TDECQ Reference Receiver Precursor Constraint

Phil Sun, Credo

IEEE 802.3cd Interim, May 2018

Proposed Changes for 100GBASE-DR

Figure 140–4—TDECQ reference equalizer functional model

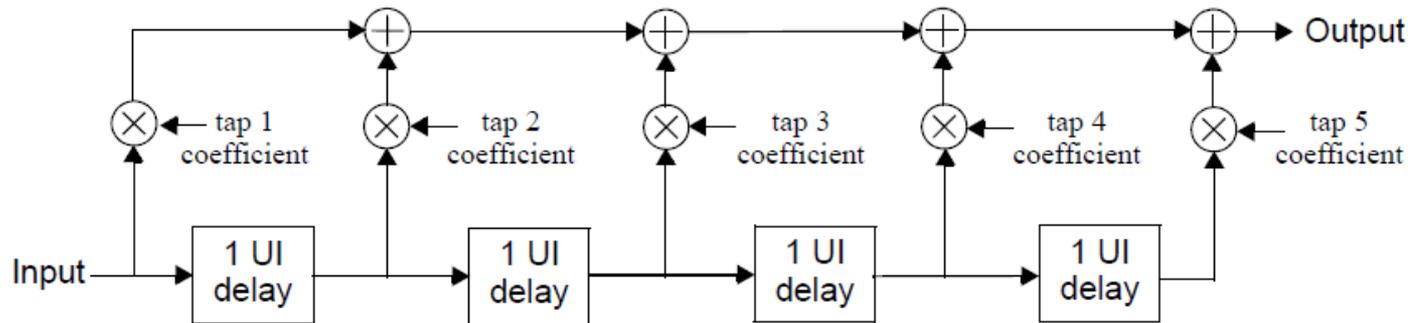
140.7.5.1 TDECQ reference equalizer

The reference equalizer for 100GBASE-DR is a 5 tap, T spaced, feed-forward equalizer (FFE), where T is the symbol period. A functional model of the reference equalizer is shown in Figure 140–4. The sum of the equalizer tap coefficients is equal to 1. Tap 1, tap 2, or tap 3, has the largest magnitude tap coefficient.

- Changes:
Tap 1 or tap 2, has the largest magnitude tap coefficient.
